STAFF RECOMMENDATION
1912 Franklin Avenue
November 16, 2016

Application: New construction—detached accessory dwelling unit
District: Eastwood Neighborhood Conservation Zoning Overlay
Council District: 06
Map and Parcel Number: 08306028500
Applicant: David Lewellyn, Owner
Project Lead: Sean Alexander, sean.alexander@nashville.gov

Description of Project: Application is to construct a detached accessory dwelling unit (DADU) at the rear of the lot.

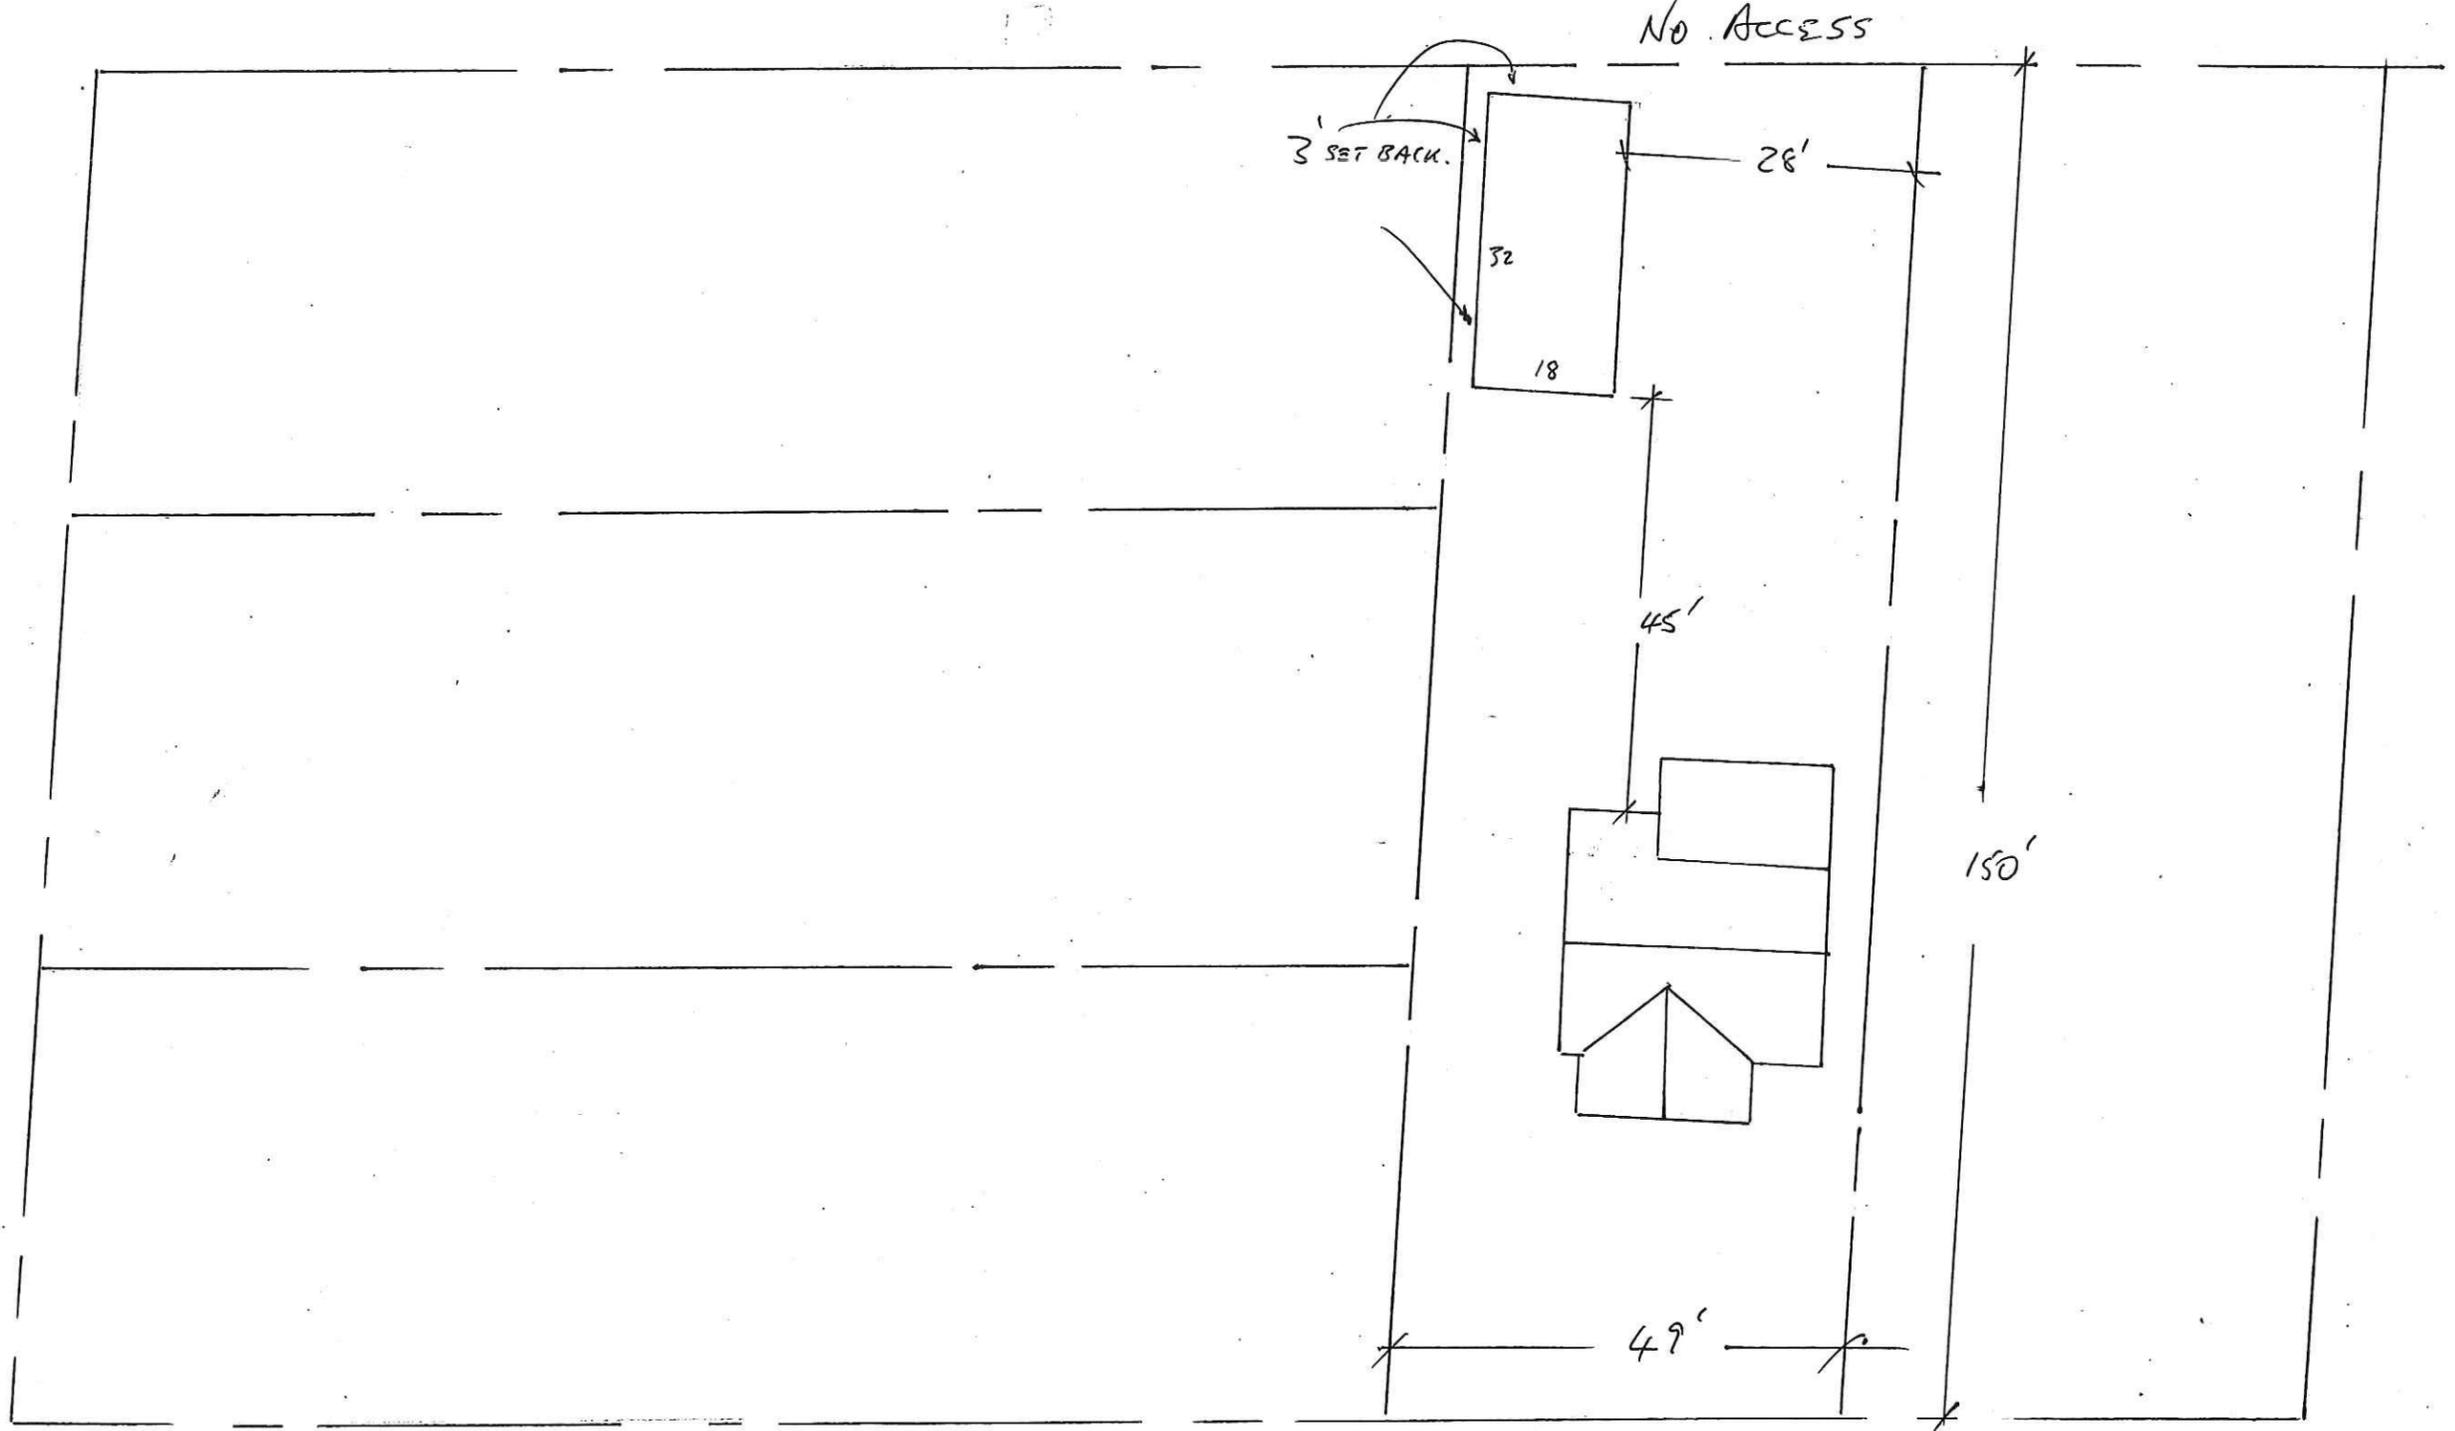
Site Planning, Setbacks:

MINIMUM	PROPOSED
Space between principal building and DADU/Garage	20'	40'
Rear setback	3'	3'
L side setback	3'	3'
R side setback	3'	29'
How is the building accessed?	From the alley or existing curb cut	n/a (no vehicle doors)

The proposed structure will be at the rear of the lot, in a typical location for outbuildings historically. The building will meet the setbacks required by zoning, and Staff finds that the proposed location is an appropriate distance from the historic house.

The project meets sections II.B.1.h.1 and II.B.1.h.2 of the design guidelines and 17.16.30.G.4 of the ordinance.

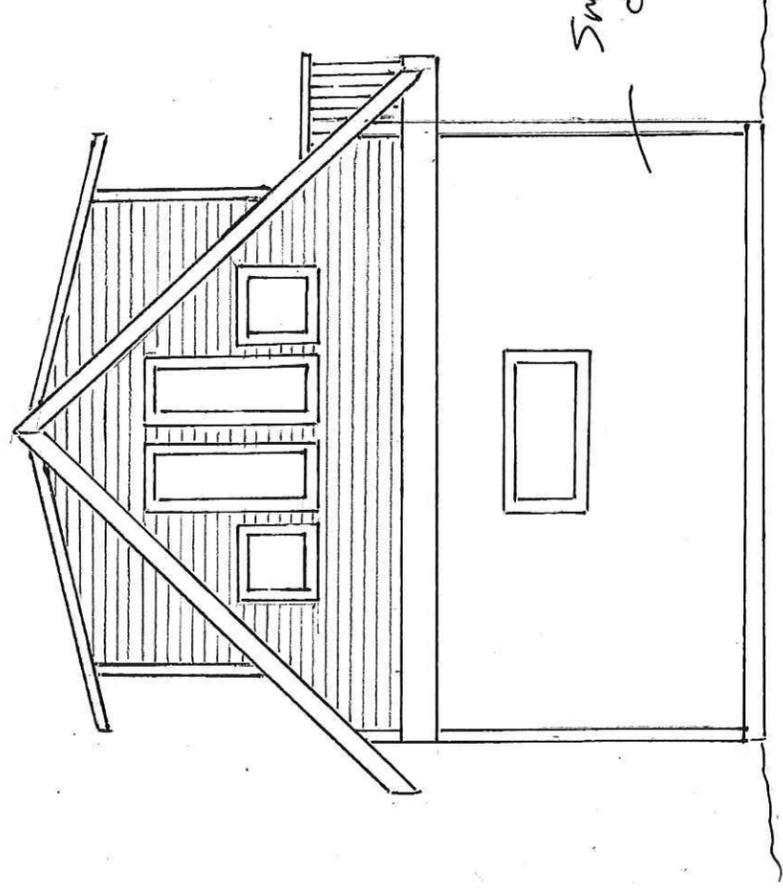
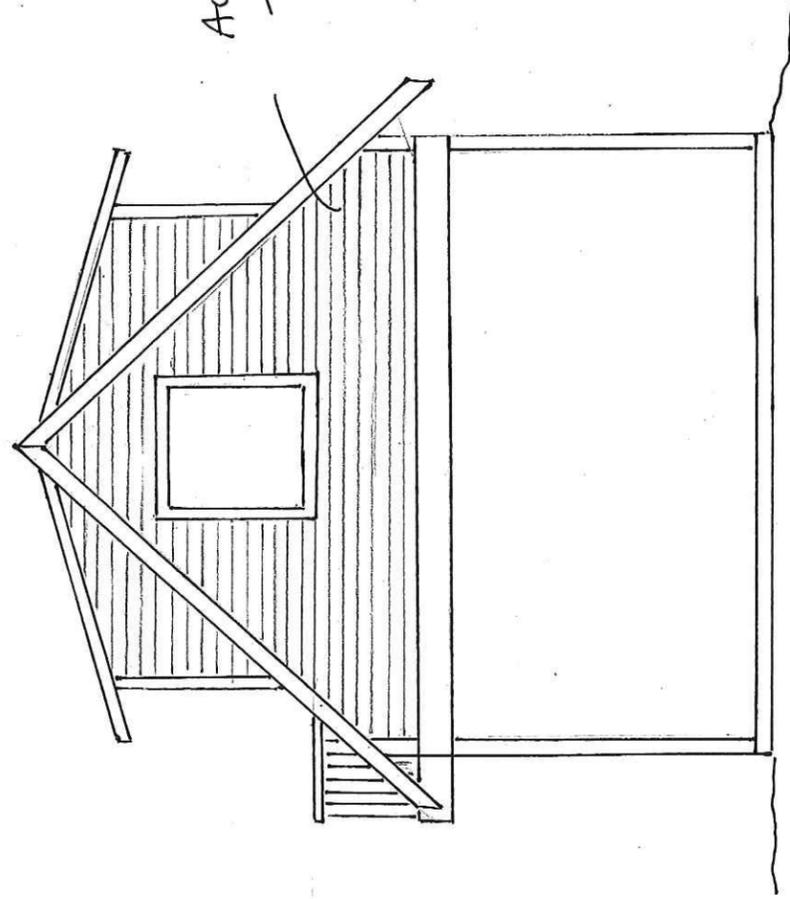
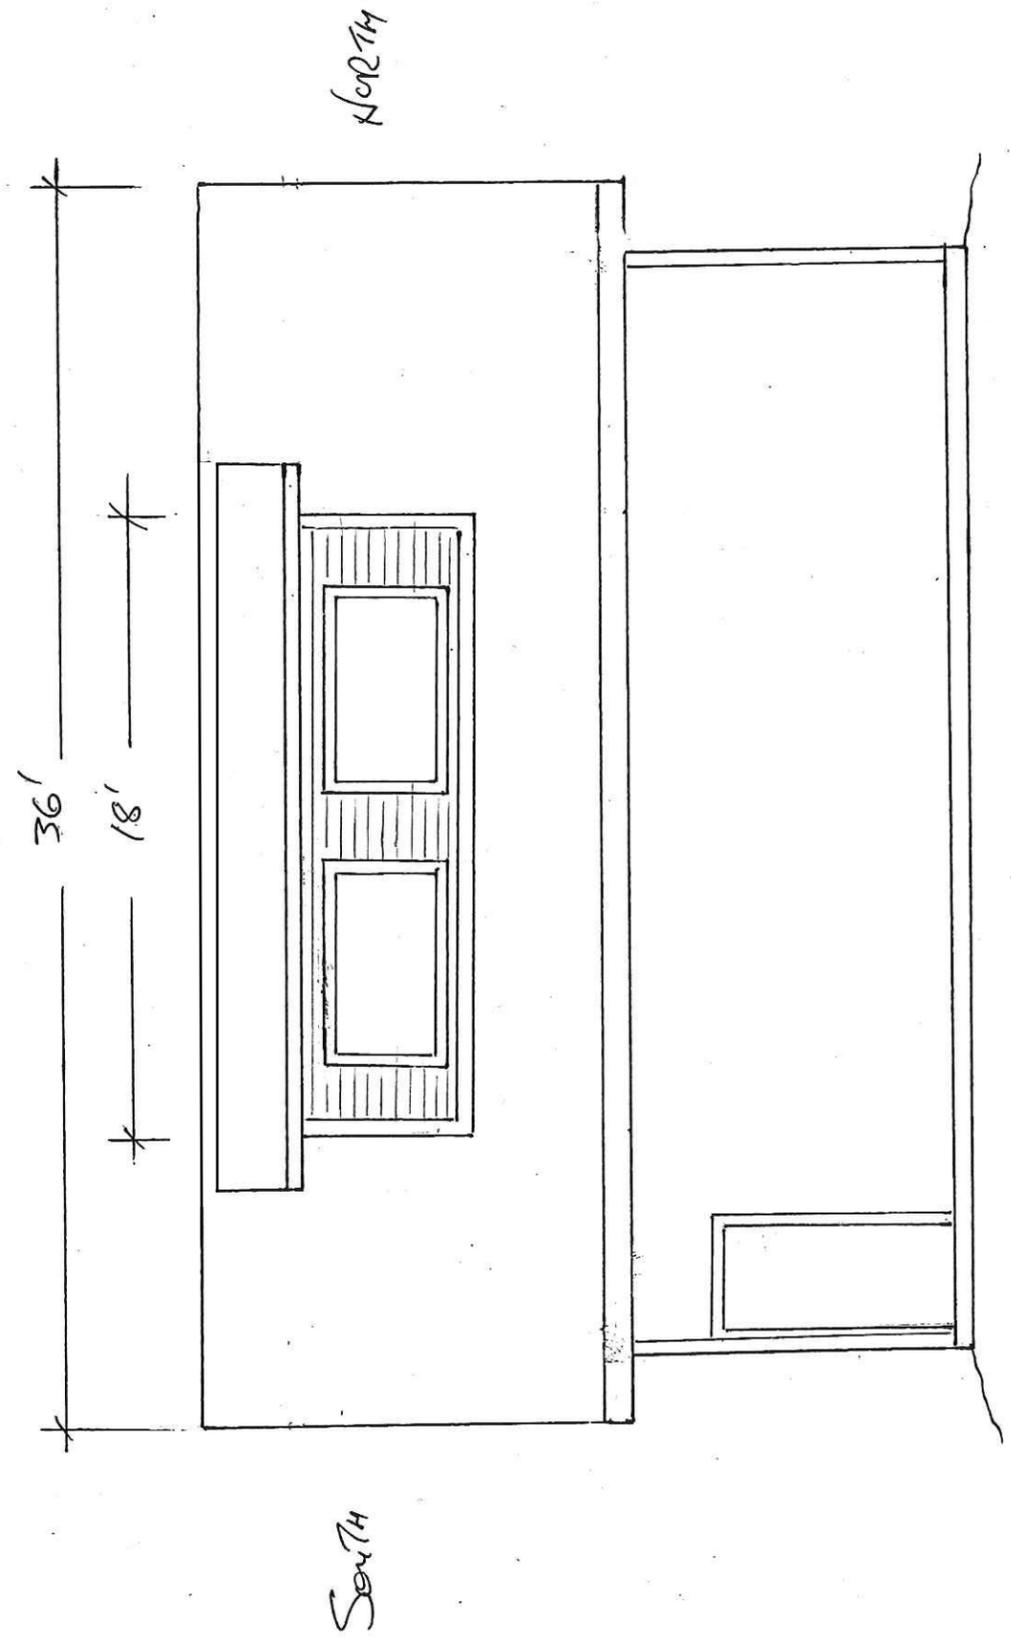
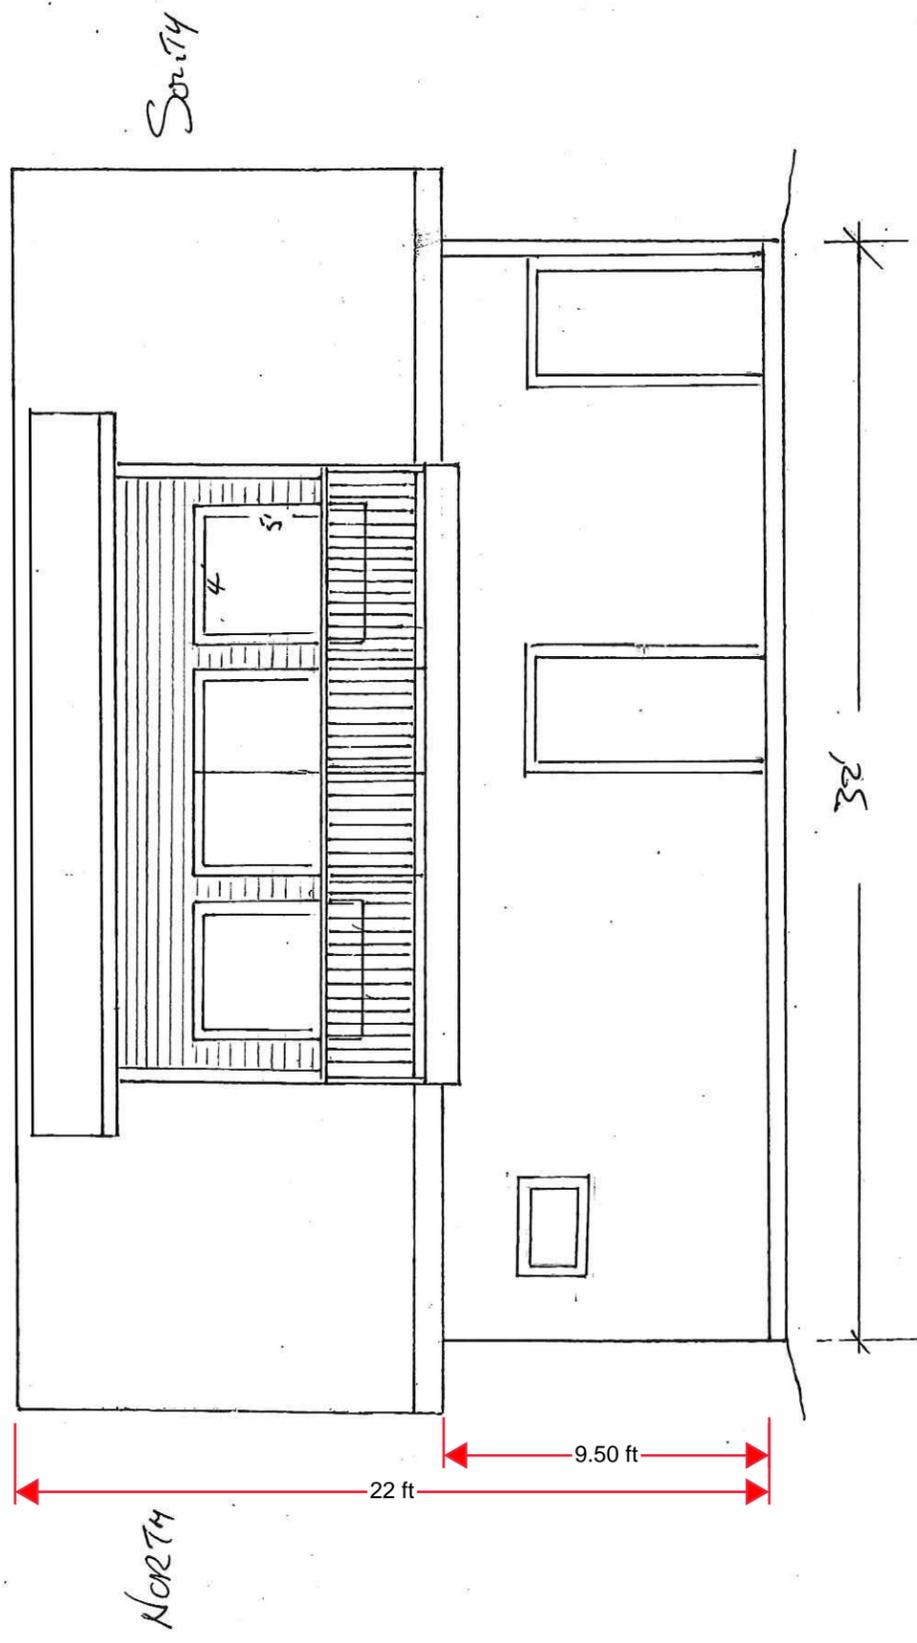
Design Standards: The accessory structure has a simple, utilitarian design that is appropriate for outbuildings. Its roof form and pitch will be typical of historic outbuildings in the area and will not contrast greatly with the primary structure. The fenestration is minimal, but not uncharacteristic for an outbuilding. It is also in a minimally-visible location at the side and rear of the building. The design meets section II.B.1.h.1 of the design guidelines and Section 17.16.030.G.8 of the ordinance.

Proposed Element	Proposed Form	Typical of district?
Primary form	Front-gable	X
Primary roof slope	13:12	X
Dormer roof form	Shed, set 2' back and 6" below ridge	X
Dormer roof slope	3:12	X
Porch form	n/a	X
Porch slope	n/a	X

Since the form and pitch is similar to historic outbuildings, the project meets Section II.B.1.h.1 of the design guidelines and section 17.16.030.G.8 of the ordinance.

Proposed	Color/Texture	Approved Previously or Typical of Neighborhood
Foundation	Concrete slab	Natural color	X
1st Story Cladding	Stucco on concrete block	Smooth	X
2nd Story Cladding	Cement-fiberboard	Smooth, match exposure on house	X
Trim	Cement-fiberboard	smooth	X
Balcony railing	Wood	n/a	X
Roofing	Asphalt shingle	Matching house	X
Driveway	Existing, no change	n/a	n/a
Windows	Not indicated	Needs final approval	X
Pedestrian Doors	Not indicated	Needs final approval	X
Vehicular Door	n/a	n/a	n/a

With the staff's final approval of the windows and doors and material information that has not yet been provided, staff finds that the known materials meet Section II.B.1.h.1 of the design guidelines.

1. Staff shall approve the final window and door selections prior to purchase and installation; and,
2. A restrictive covenant for the detached accessory dwelling unit shall be filed prior to issuance of a permit.
